MODERNIZATION AT CURRAN MIDDLE SCHOOL FOR:

MARK	DATE	DESCRIPTION
SD		
CD		
01	05/15/07	ADDENDUM 1

SHEET TITLE
ENLARGED FLOOR PLA
BLDG D & PARTIAL
FLOOR PLAN BLDG F

SHEET IDENTIFICATION NUMBER
A-422
SHEET 35 OF 46

C2 FLOOR PLAN BUILDING 'D'

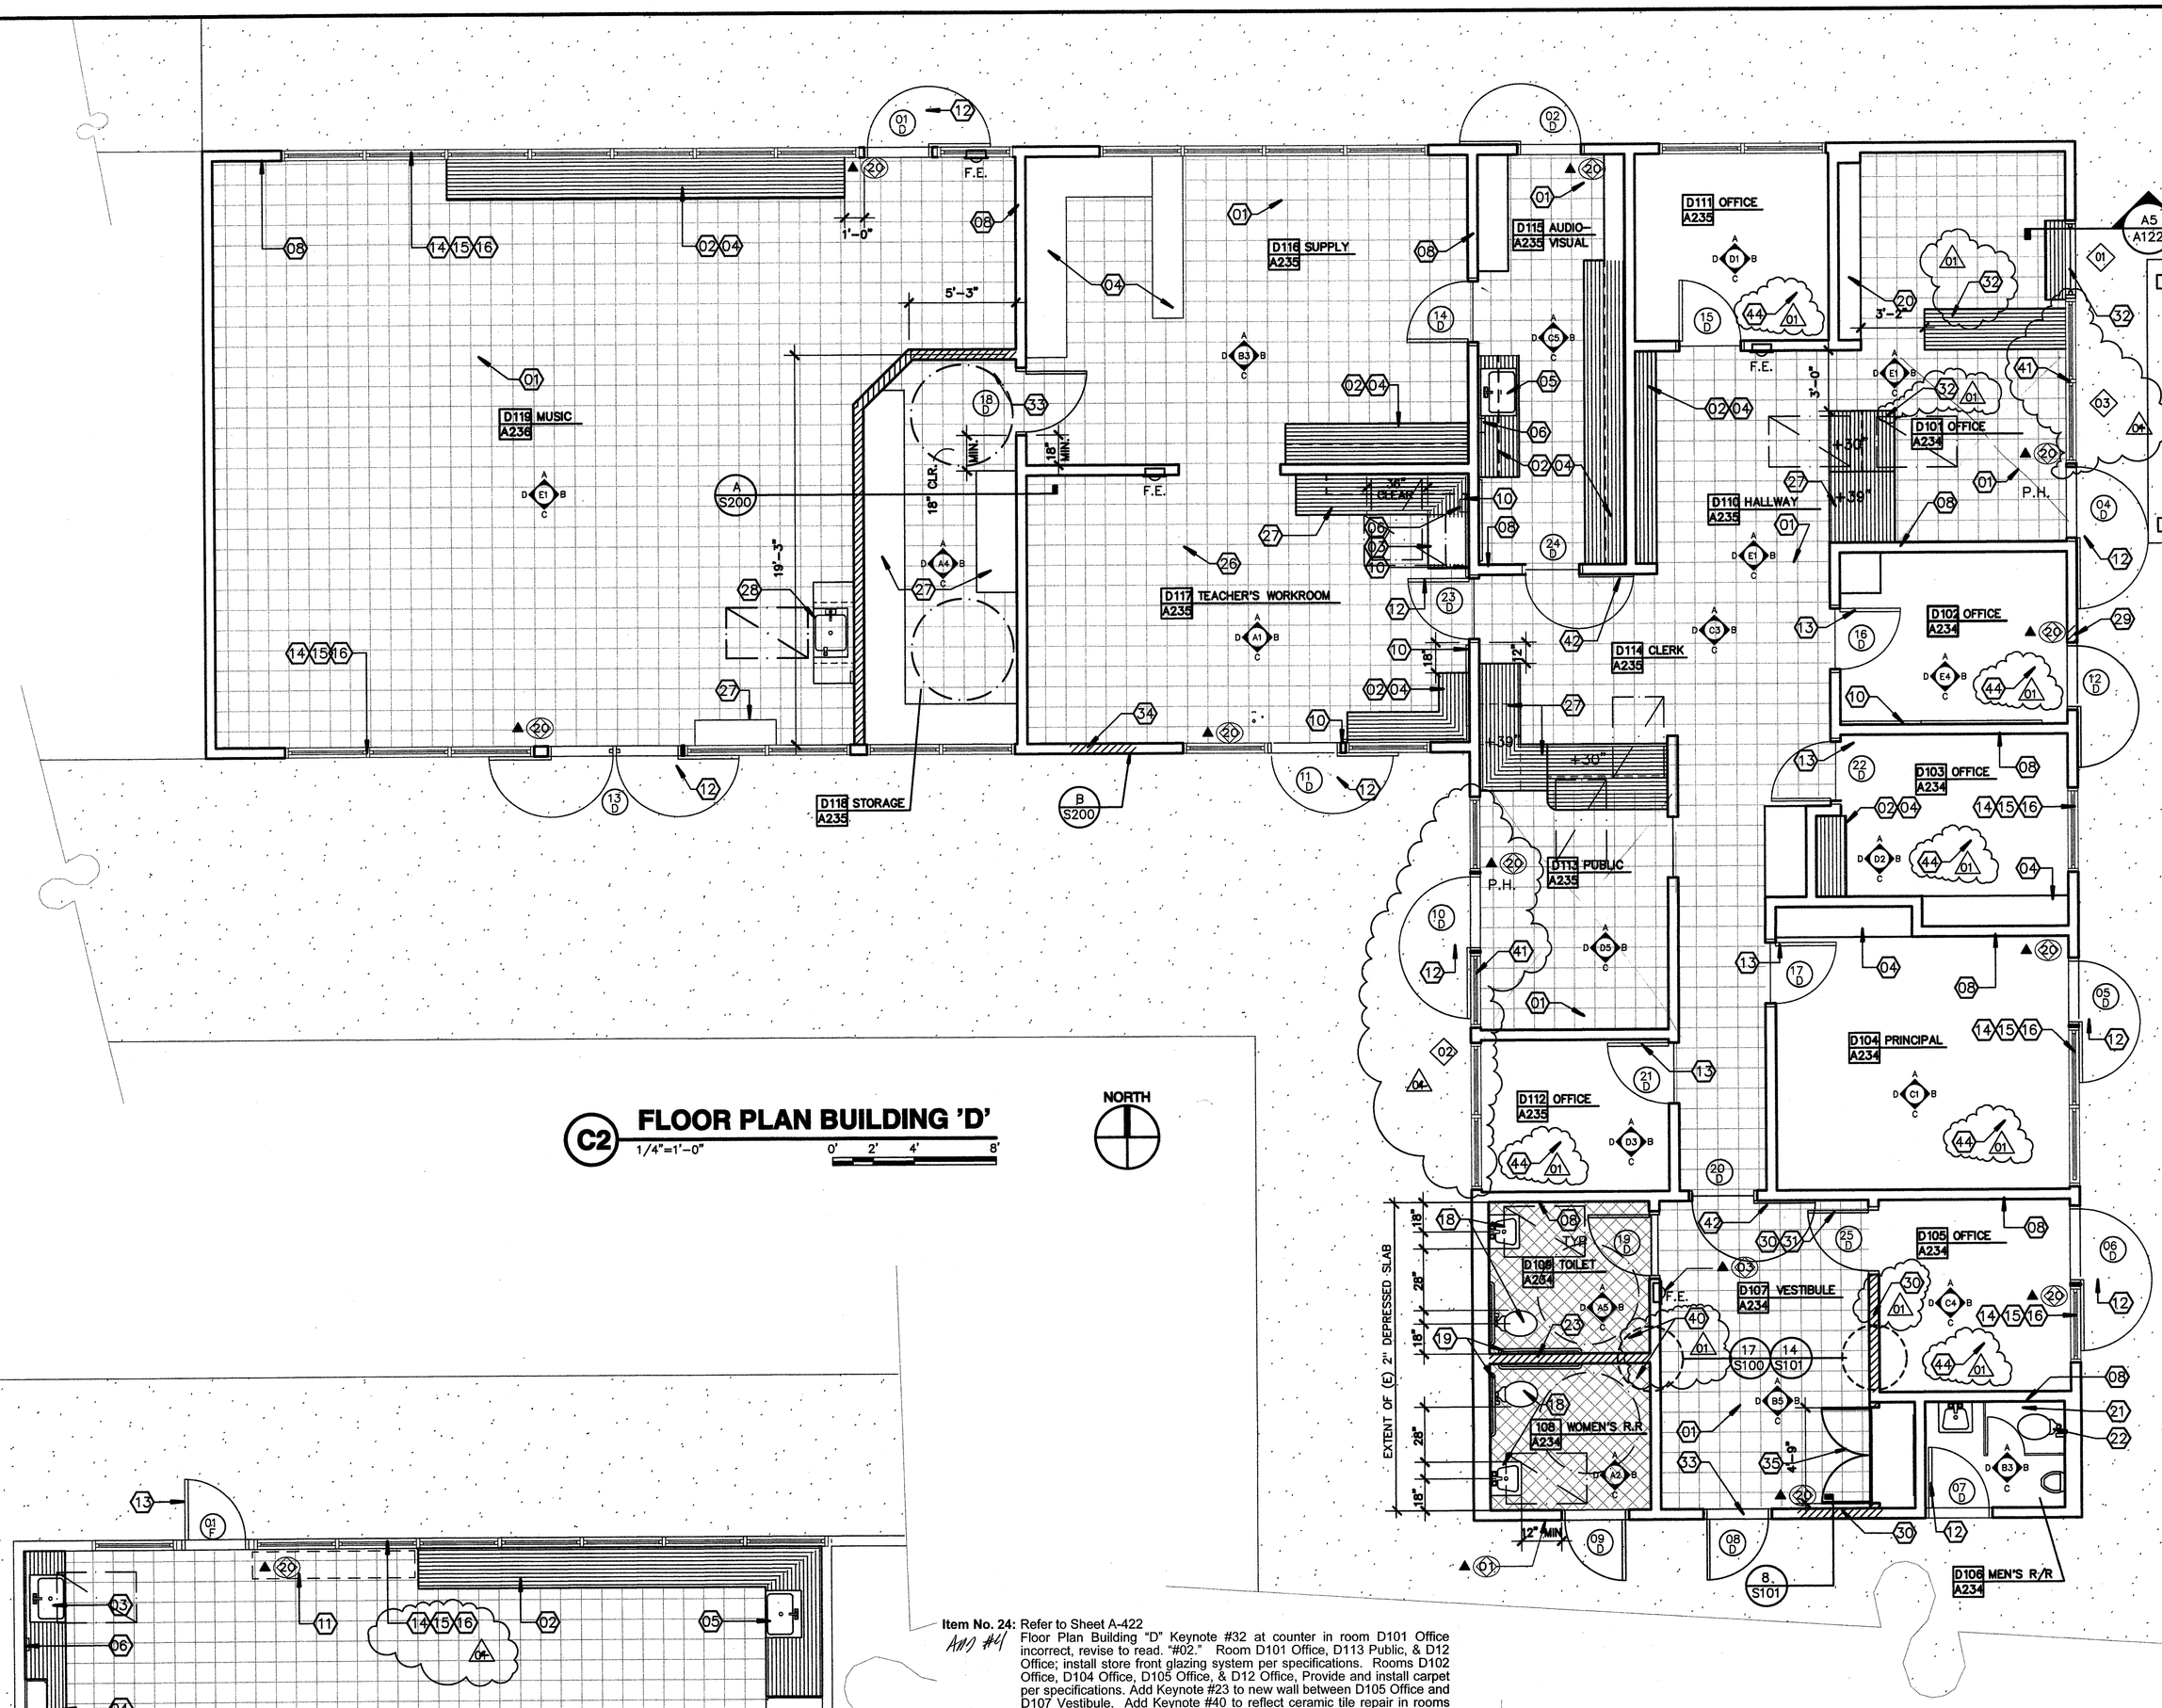
Item No. 24: Refer to Sheet A-422
Add'l #4
Floor Plan Building "D" Keynote #32 at counter in room D101 Office incorrect, revise to read. "#02." Room D101 Office, D113 Public, & D12 Office; install store front glazing system per specifications. Rooms D102 Office, D104 Office, D105 Office, & D12 Office, Provide and install carpet per specifications. Add Keynote #23 to new wall between D105 Office and D107 Vestibule. Add Keynote #40 to reflect ceramic tile repair in rooms D108 and D109. Keynotes #05 at cabinets incorrect revise to read. "#04." Enlarged Floor Plan "A1" Add Keynote #28 to reflect flooring repair required. Floor Plan Building "F" Math Room Keynote #06 at window incorrect, revise to read. "#16." Building "H" Girls Toilet, delete Keynote #37. Keynote #36 at grab-bar incorrect, revise to read. "19." Revise Keynote #01 to read. "Install flooring per specifications." Revise Keynote #02 to read. "Remove and replace existing counter top with corian countertop with 6" splash (unless noted otherwise) calk to wall typical." Revise Keynote 03 to read. "Replace existing sink cabinet with ADA compliant sink cabinet, typical all sink cabinets." Revise Keynote #4 to read. "Existing cabinet to remain, remove and replace all doors, drawer fronts, & face plates. Finish per specifications." Revise Keynote #05 to read. "Remove and replace existing plumbing fixtures see plumbing plans for further requirements." Revise Keynote #08 to read. "Patch and repair damaged walls as required. Prep prime and paint all existing plaster walls. See structural drawings for sheer wall requirements." Delete Keynote #25. Revise Keynote #27 to read. "Provide and install corian countertop and accessible cabinet see interior elevations." Revise Keynote #41 to read. "Provide and install store front glazing system per specifications." Revise Keynote #43 to read. "Provide and install corian countertop with accessible cabinet with modesty panel." Add Keynote #44, "Carpet per specifications."
